TECHNICAL SERVICE BULLETIN

2.7L EcoBoost - Oil Pan Leaking, Original Replacement Pan Not Available

23-208317 March
2023

This bulletin supersedes 19-2205.

Figure 1

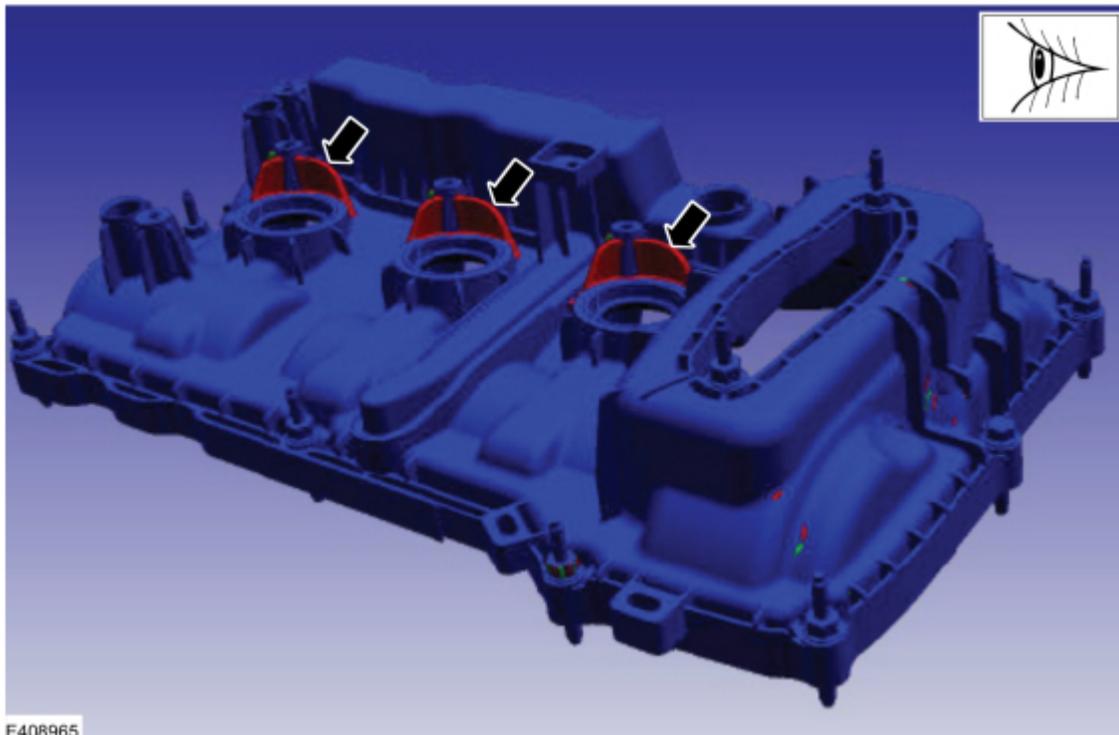
1. Inspect the valve cover design around the ignition coils. Does the coil location have the extended plastic protective ribbing as shown in red? (Figure 1)

- (1). Yes - proceed to Step 3.
- (2). No - proceed to Step 2.

2. Replace the valve covers. Refer to the procedures in the 2015-2017 F150 Workshop Manual (WSM), Section 303-01A, Removal and Installation > Valve Cover LH and Valve Cover RH.
3. Replace the oil pan. Refer to the various WSM years as required.
 - (1). 2015-2017 F-150 WSM, Section 303-01A, Removal and Installation > Oil Pan, Removal, Steps 1-32.
 - (2). 2018 F-150 WSM, Section 303-01A, Removal and Installation > Oil Pan, Removal, Steps 31 and 32.
 - (3). 2018 F-150 WSM, Section 303-01A, Removal and Installation > Oil Pan, Installation, Steps 1-3.
 - (4). 2015-2017 F-150 WSM, Section 303-01A, Removal and Installation > Oil Pan, Installation, Steps 4-39.
